IMPORTANT PRODUCT INFORMATION

Product: **PANELWARE™ MMI System**
IC641SWP950 PANELWARE Configuration Software Version 1.8
IC750CTR200 C200 Basic Controller
IC750CTR400 C400 Genius™ Controller
IC750CFL840 8x40 Graphic CFL Display
IC750KBL160 16 Key/16LED Block
IC750KBL400 Numeric Key Block
IC750KBL840 8 Key/4LED Block
IC750KBL440 4 Key/4LED Block
IC750KBL910 Emergency Stop Block
IC750KBL920 Keyswitch Block
IC750KBL930 Start/StopBlock

Software Id: Version 1.8 (IC641SWP950B)

Replaces Version 1.71 (IC641SWP950A)

Keyswitch and ON/OFF (IC750KBL920)

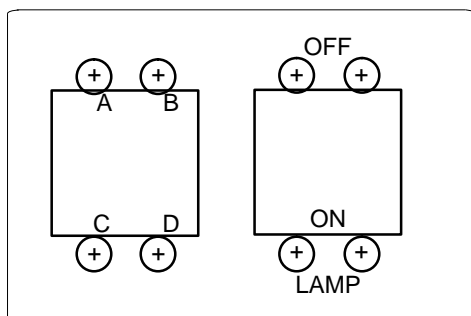
Revision B (and later) Keyswitch Blocks are not interchangeable with revision A Keyswitch Blocks. Because the type of OFF switch has been changed, the two versions operate differently. When you replace an A version of the module with a B version (or vice-versa), you must also modify your system configuration accordingly before power up.

In **revision B** of the Keyswitch Block, the OFF contacts are normally closed and open momentarily when the OFF switch is pressed.

In **revision A** of the Keyswitch Block, the OFF contacts are normally open and close momentarily when the OFF switch is pressed.

Revision A	Revision B
Keyswitch contacts 10 Amps 220 VAC; 7.5 Amps @ 380 VAC	1-NORMALLY CLOSED, 1-NORMALLY OPEN	1-NORMALLY CLOSED, 1-NORMALLY OPEN
ON switch contacts 10 Amps 220 VAC; 7.5 Amps @ 380 VAC	NORMALLY OPEN	NORMALLY OPEN
OFF switch contacts 10 Amps 220 VAC; 7.5 Amps @ 380 VAC	NORMALLY OPEN	NORMALLY CLOSED
